Technical Service Bulletin

48 Creaking or squeaking noises from steering column (sealing boot)

48 16 69 2034351/6 March 18, 2016. Supersedes Technical Service Bulletin Group 48 number 15-66 dated July 30, 2015 for reasons listed below.

Figure 1. Sealing sleeve on the bulkhead.

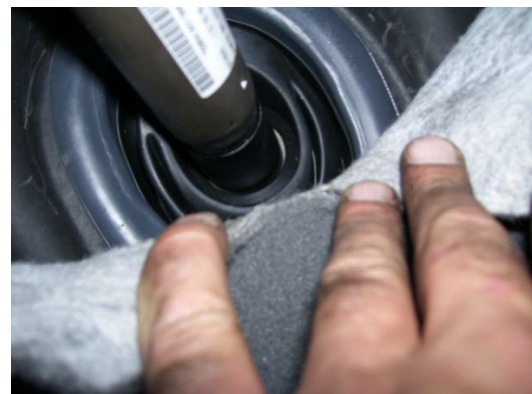
1. Check the sealing sleeve for proper installation and fit (Figure 1).
2. To eliminate the noise, loosen the upper bolted connection of the steering intermediate shaft and the steering column. Pull the intermediate steering shaft out about 4 in (10 cm) and spray the special lubricant spray (**G052172M2**) in the area of the bearing ring and the black plastic sleeve. Push it in and pull it out a few times to distribute the spray on the intermediate steering shaft.

Do not lubricate the u-joints of the steering shaft.

3. Retighten the shaft with a new bolt on the steering column.
4. If the noise persists, replace the intermediate steering shaft.
